COUNCIL ASSESSMENT REPORT

Panel Reference	PPSSCC- 687
DA Number	397/2020/A PAN-524135
LGA	City of Parramatta Council
Proposed Development	Section 4.56 modification of DA/397/2020 for demolition of existing structures, site preparation works, excavation, tree removal, construction of five 5-8 storey residential flat buildings over basement car parking. The application was Integrated Development under the Roads Act 1993 and the Water Management Act 2000. The modification is seeking to operate as Build-to-Rent housing, provide an additional 66 units, make changes to the building envelope and façade, reduce the basement extent, and add additional communal amenities and facilities. The modifications also seek to modify the consent to allow the staged construction of the development. The modification application is to be determined by the Sydney Central City Planning Panel.
Street Address	2 – 6 Epping Road and 2 – 4 Forest Grove EPPING

This report considers a Section 4.56 modification application to an approved demolition, site preparation works, excavation and tree removal; construction of a 5 x 5 – 8 storey residential flat building comprising 321 apartments, 2 x 2 – 3 level basement

Figure 4: Extent of height departures

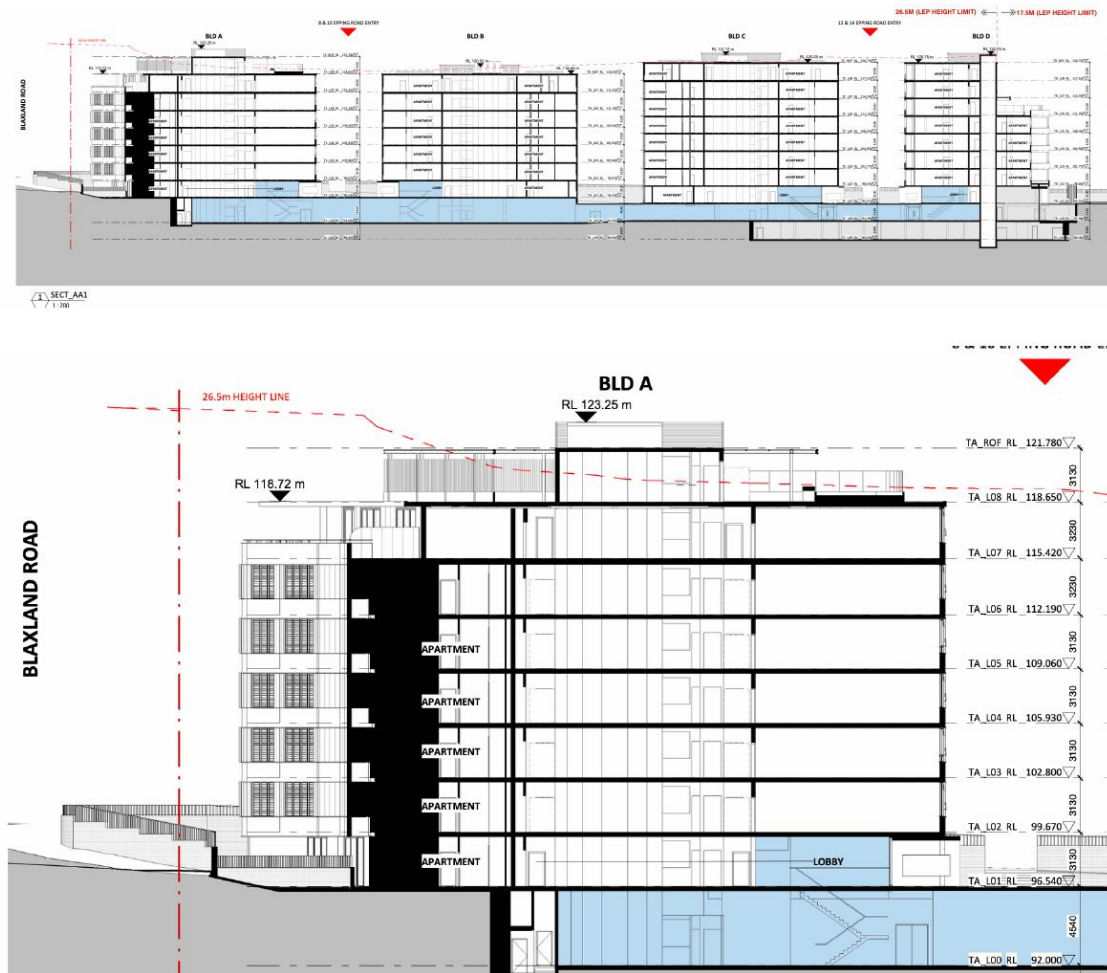
PARRAMATTA LOCAL ENVIRONMENTAL PLAN 2023		
Standards and Provisions	Original	Modification
Cl. 4.3 Height of buildings • Max. 17.5m along Forest Grove • Max. 26.5m for remainder of the site.	Complied Forest Grove – 17.5m Remainder of Site – 26.5m	No, but acceptable on merit Proposed: Forest Grove – 17.5m Remainder of Site – 30.76m (departure of 4.26m or a variation of approximately 16% from the standard)
Assessment of variation to Height Applications assessed under Section 4.56 of the EPA Act 1979 do not require a variation to be sought under Clause 4.6 of the Parramatta LEP 2023. Notwithstanding, a merit assessment of the variation is provided below. The applicant has provided the following commentary to support the variation to the Height: <i>In response to National Construction Code requirements, and to improve apartment amenity, the modification application increases the floor to floor heights from that approved. In addition, the modification improves the communal open space provision through the introduction of roof top communal open space to Building A, to be accessed by a lift. The cumulative impact of these improvements as that there are minor breaches to the height of building control.</i> <i>It is noted that the application is a Clause 4.56 modification application and the statutory test is that of whether the modification is “substantially the same” as that approved. The test is not against the development standard and there is no statutory trigger or requirement for a Clause 4.6 variation to the development standard.</i> <i>Notwithstanding the following relevant information and commentary is provided in relation to the height of building –</i> • <i>The most significant difference is Building A, due to the introduction of the roof top open space and the need for the lift to provide access. The section extracts below illustrates this clearly.</i> • <i>It is noted the there is no habitable apartment floor space located above the height of building line of 26.5m.</i>

- The built form that extend above the 26.5m height are set back from the edge of the building ensuring that these areas are visually recessive and generally not visible from the public places adjoining the development site.
- The upper part of Building A has been designed with architectural features and finishes (eg decorative metal cladding) to ensure that in any instance that the upper part of the building can be seen that it is akin to an architectural roof feature.

In review of the proposed changes to the height of the development and the proposed departure to the maximum height standard, the following is noted:

- It is acknowledged that the development has been designed to comply with the amendments to the National Construction Code with regards to floor-to-floor heights and that as a result, it has increased the overall height of the development which at parts of the modified proposal, exceeds the maximum height for the site.
- The change to the floor-to-floor heights under the NCC ensures that the units will achieve improved internal amenity.
